SUBJECT: Transition Detail

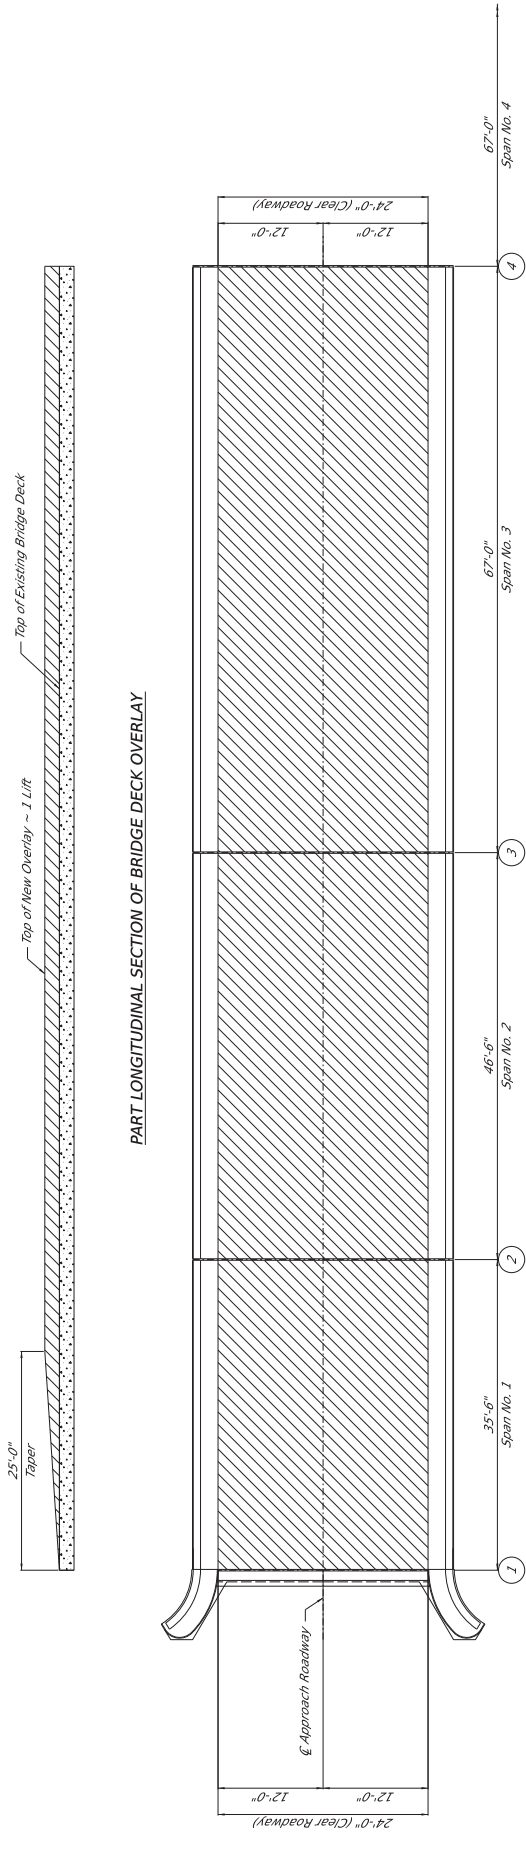
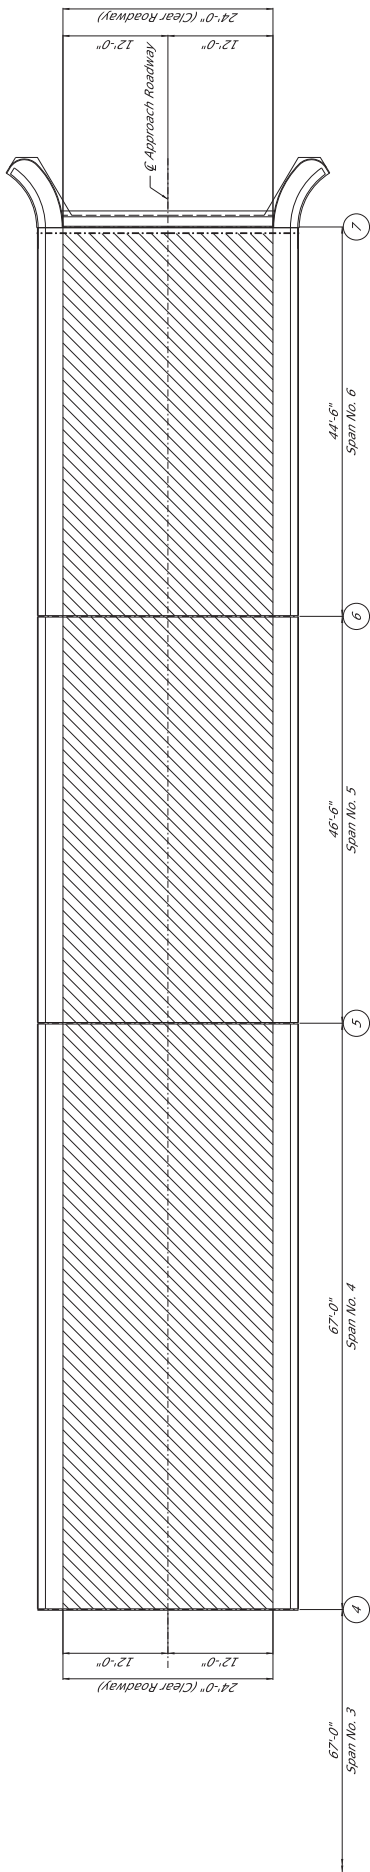
Bidders are advised that the following drawing shall be used for the transition details in the placement of the Hybrid Polymer Concrete Overlay unless otherwise directed by the Engineer.
